**STAFF RECOMMENDATION**

**313 Wilson Blvd**

**August 15, 2018**

**Application:** New Construction – Addition with Setback Determination

**BOUNDARY AND TOPOGRAPHIC SURVEY**

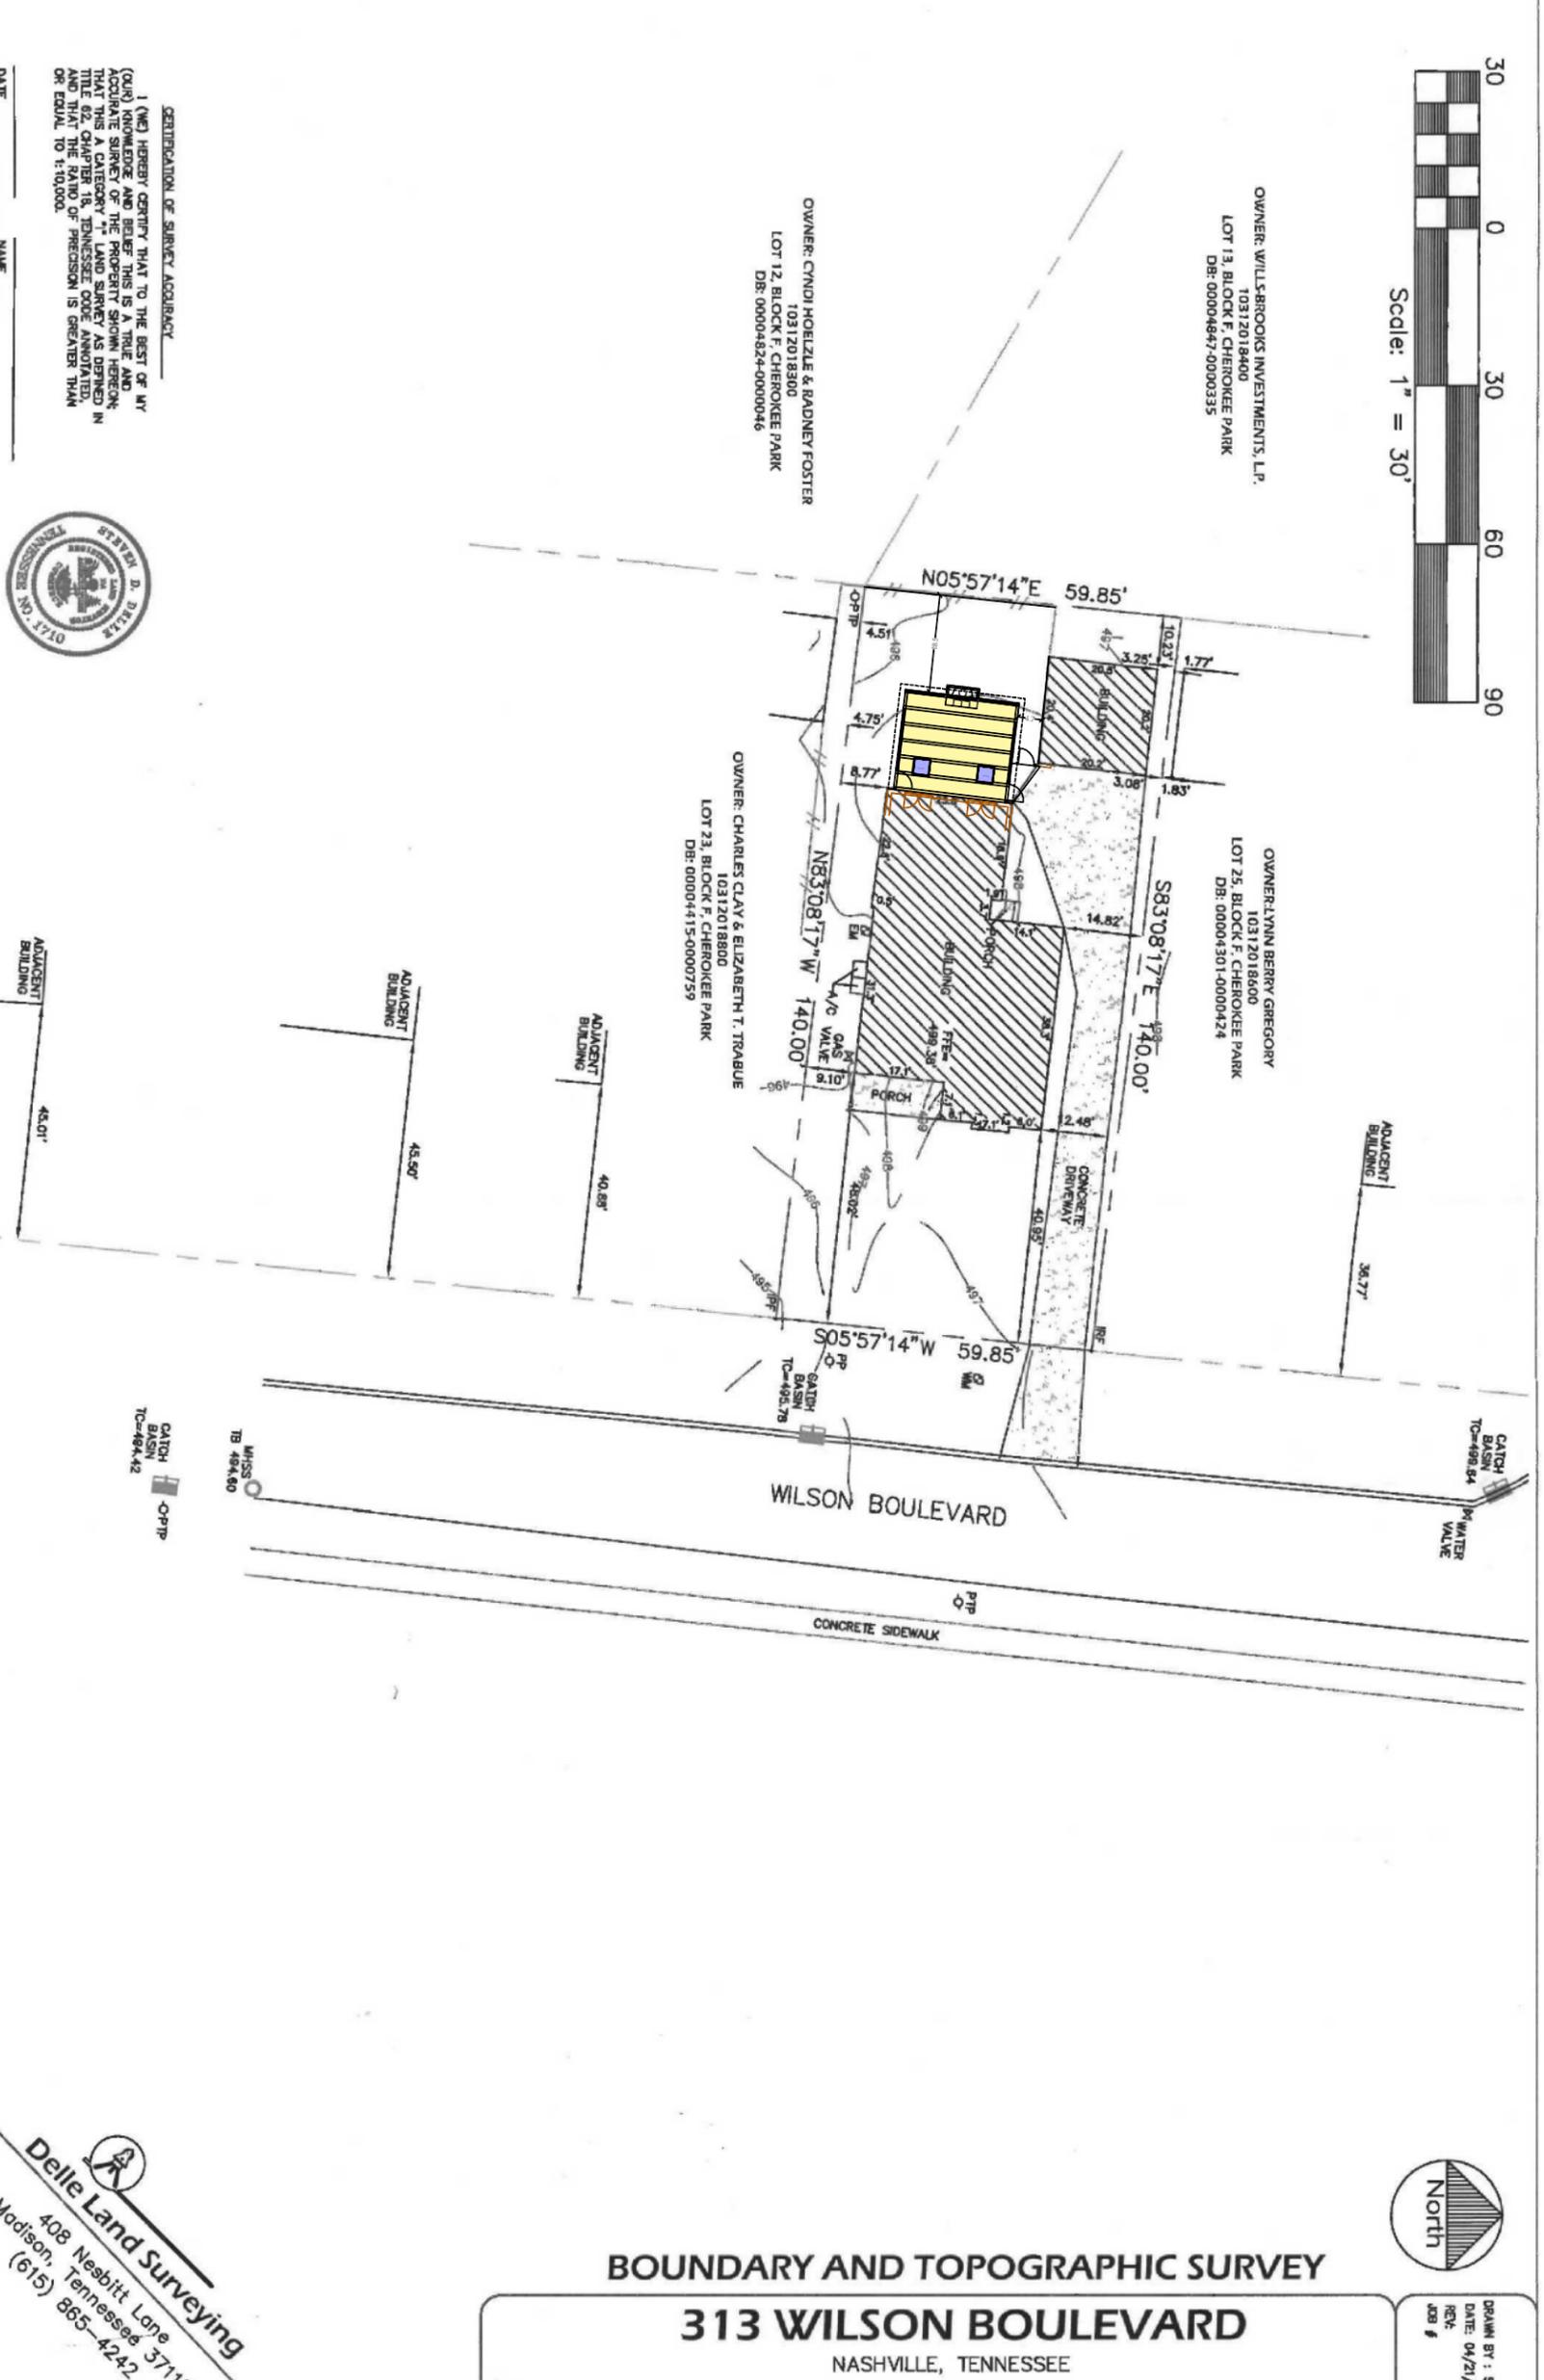
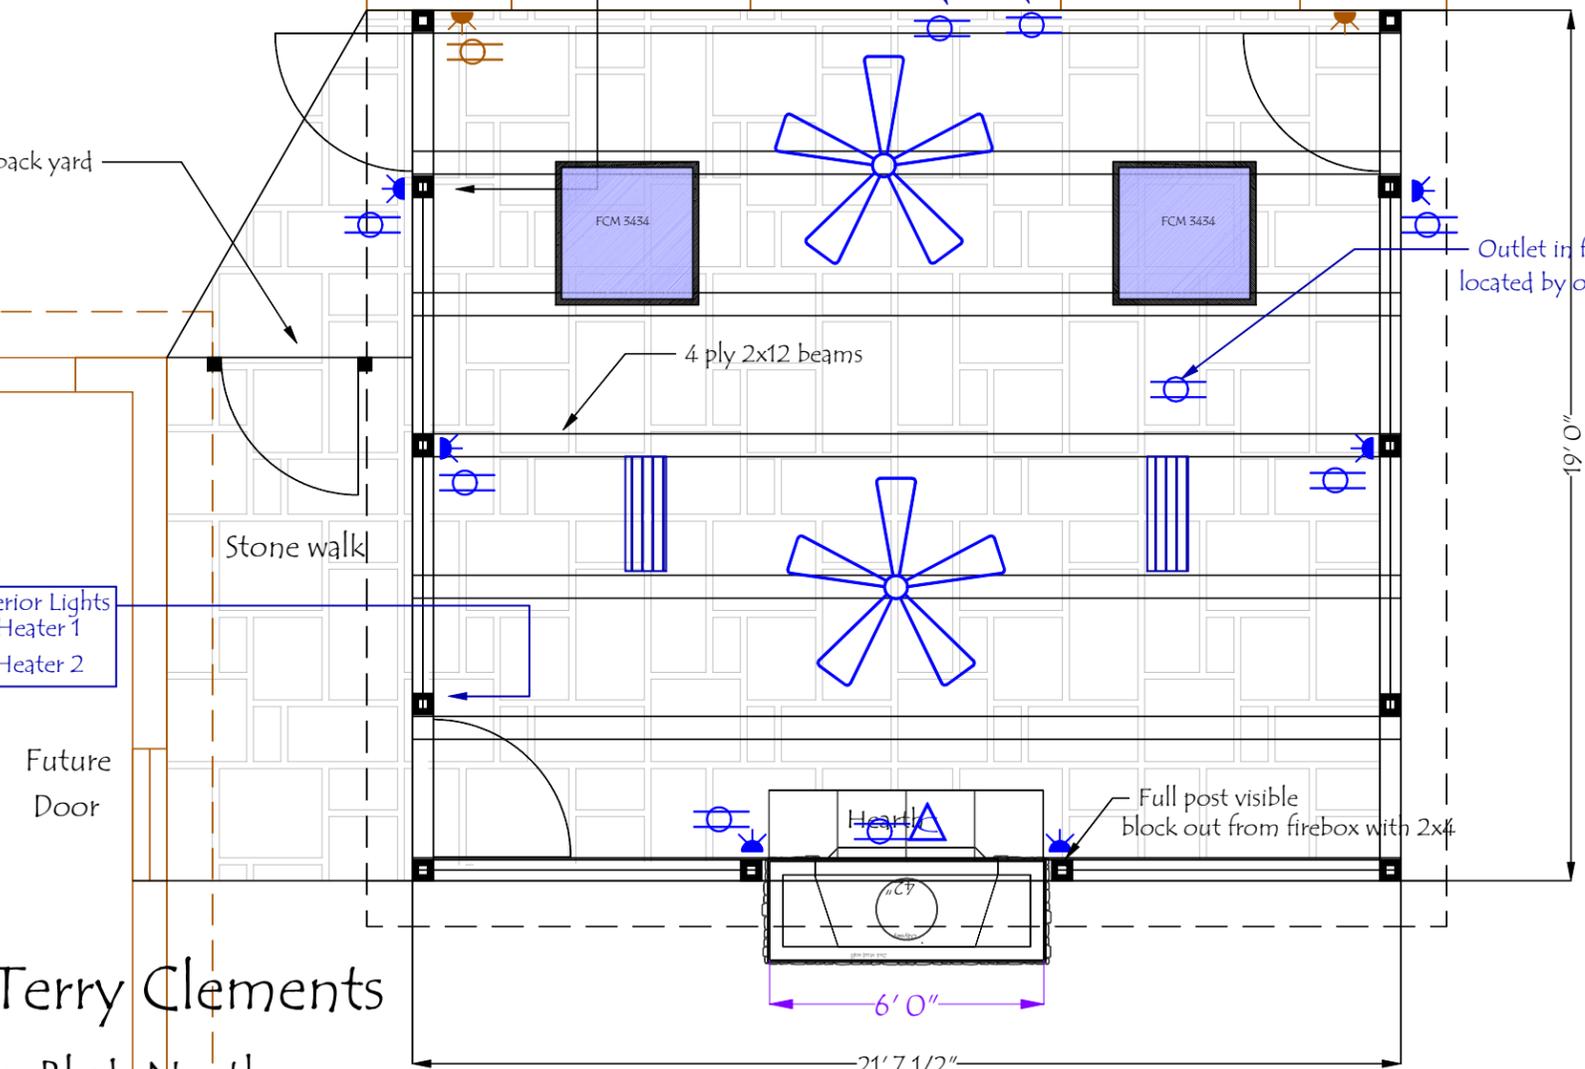
The proposed new construction meets the side setback requirements but not the rear twenty-foot (20') rear setback as it is only eighteen feet, six inches (18'6") from the rear property line. In addition, as designed, the porch comes within approximately four feet, six inches (4'6") of the side of the existing garage. The design guidelines recommend a twenty foot (20') separation between a house and an outbuilding. In the past, the Commission has allowed shorter separations in specific cases due to individual site circumstances.

This property has a small back yard with a little less than forty feet (40') from the back wall of the house to the rear property line. The existing garage sits in the rear corner of the property, about ten feet (10') from the rear property line and about three feet (3') from the side property line. Currently, the garage is only about nine feet (9') from the corner of the house (Figure 3). Building the screen porch as proposed will bring it to about four feet, six inches (4'6") from the side of the garage. Staff finds that the four hundred (400) square foot porch is a modest addition and that given the existing location of the garage, the need to keep the porch behind the house, and the need to maintain an appropriate rear setback, the proposed location could be appropriate.

Base zoning requires that the house be twenty feet (20') from the rear property line, and the proposed porch is only eighteen feet, six inches (18'6") from the rear property line. Because of the substantial forty foot (40') front setback, and the open nature of the screen porch, Staff finds that reducing the rear setback to eighteen feet, six inches (18'6") could be appropriate in this case. In addition, the open porch will be no closer to the rear property line than the existing garage.

Staff finds that the project meets section II.B.1.c and II.B.1.h.2.

## Typical Fireplace Elevation

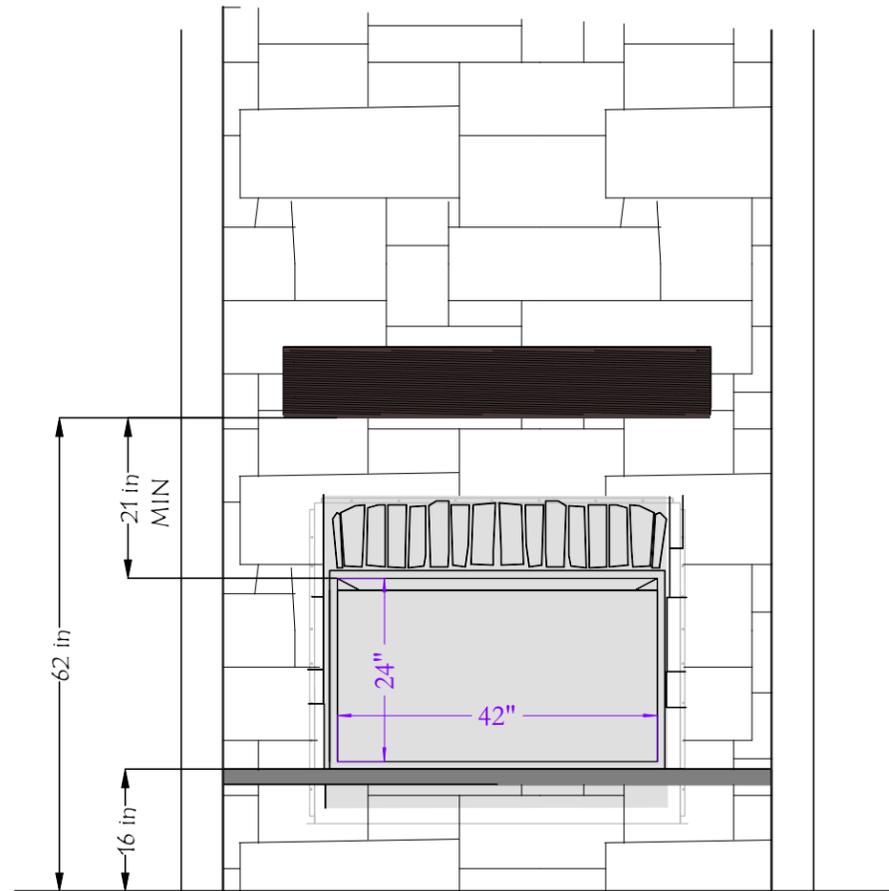
<b>Proposed</b>	<b>Color/Texture/Make/Manufacturer</b>	<b>Approved Previously or Typical of Neighborhood</b>	<b>Requires Additional Review</b>
<b>Flooring</b>	Stone	Blue stone	Yes	
<b>Roofing</b>	Rubber roofing	Pebbled	No	
<b>Trim</b>	Wood	N/A	Yes	
<b>Rear Screened Porch Posts</b>	Pressure treated laminate posts	N/A	Yes	
<b>Chimney</b>	Stone	N/A	Yes	Yes

With final staff review of the stone for the chimney, the project meets section II.B.1.d
